Technical Bulletin

Tail Light Assembly, Difficult to Remove or Lens Cracks During Removal

94 06 18 Dec. 2, 2006 2008512 Supersedes T. B. Group 94 number 05-01 dated Feb. 3, 2005 due to inclusion into ElsaWeb.

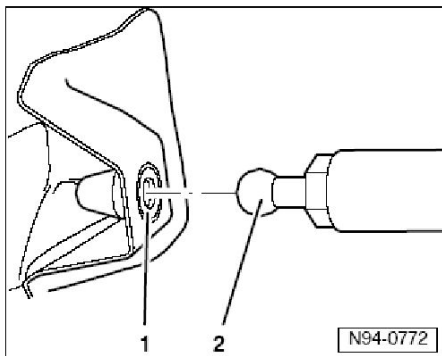
Tail light assembly is hard to remove or lens cracks during removal.

May be due to excessive retention force of the tail light retainer installed in the body.

Improved retainer Part Number 7L6905229 installed beginning with VIN 7L_5D053137.

- Replace existing retainer -1- (white) with new improved retainer Part No: 7L6905229 (black).
- Reinstall Tail light assembly.
